Access Compliance Report

Public Rights-of-Way

(Curb Ramps)

Intersection ID: 52915	Main Street: WILLOW_GREEN_PL	Cross Street: WOODWARD_AV	Location: NE
ADA ID: 124B4B16A1B5	Ramp Type: Directional1	Initial Pass/Fail: Fail	Overall Compliance: No
Severity Score: 1.25			
Codes/Mitigation Info/Possible Solution		Field Measurements/Component Compliance

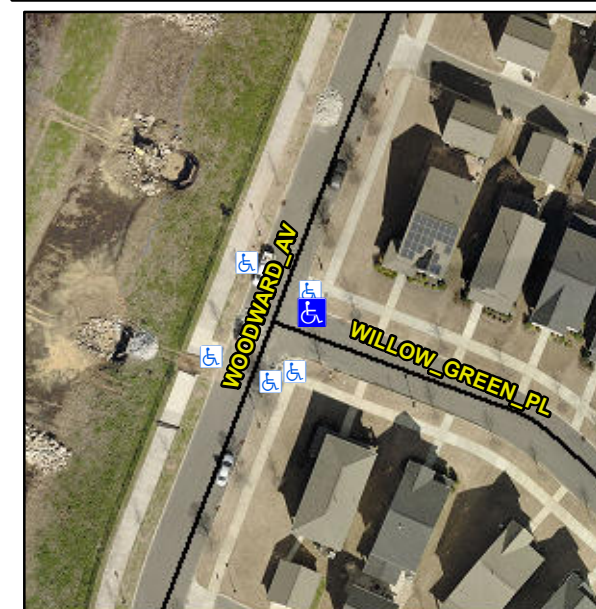
R304.5.3

Remove & Replace Entire Ramp.
